SUBJECT: NEW VEHICLE DEMONSTRATION / DELIVERY HOLD
Safety Recall 17S44 – Supplement #2
 Certain 2018 Model Year Escape Vehicles
 Side Curtain Airbag Replacement

CERTAIN 2018 MODEL YEAR ESCAPE VEHICLES — SIDE CURTAIN AIRBAG REPLACEMENT

FIGURE 1

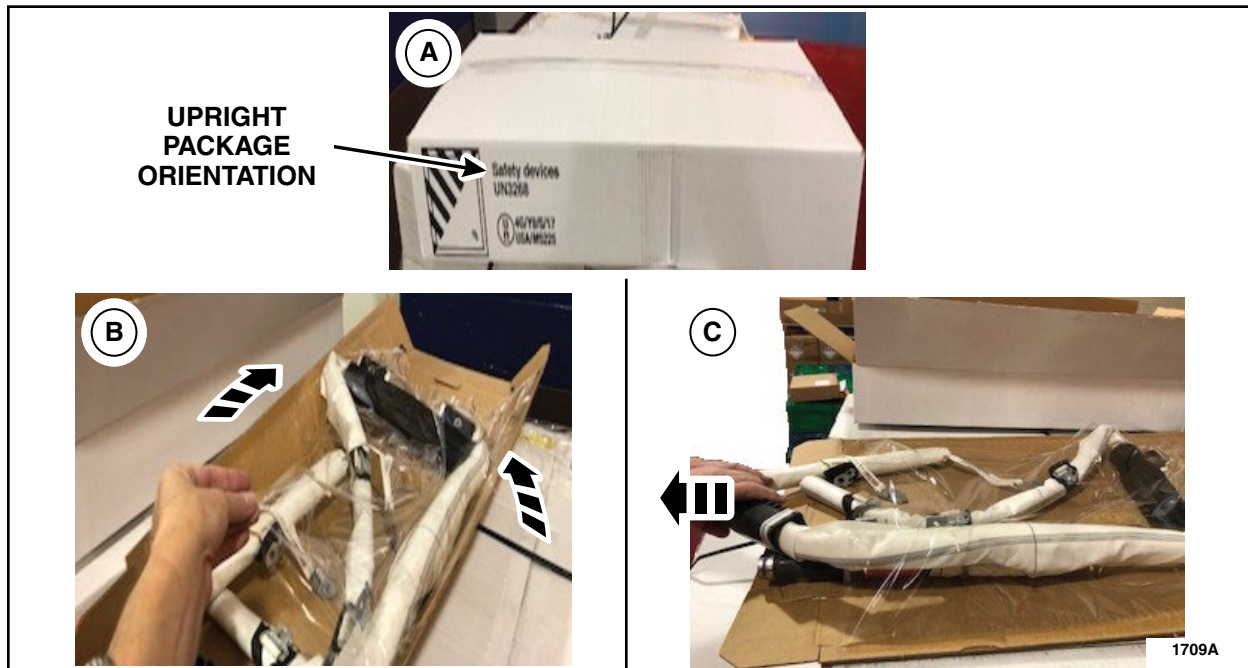
1. Remove the new replacement airbag from the box. See Figure 1.
 - a. Open the package in the upright position (text on side of box is properly oriented) and carefully remove and unfold the cardboard insert contained in the box
 - b. If necessary, fold the sides of the cardboard insert upward to loosen the plastic that secures the airbag.
 - c. Carefully remove the airbag from the cardboard insert.

2. Reverse the removal to package the old airbag(s). See Figure 1.
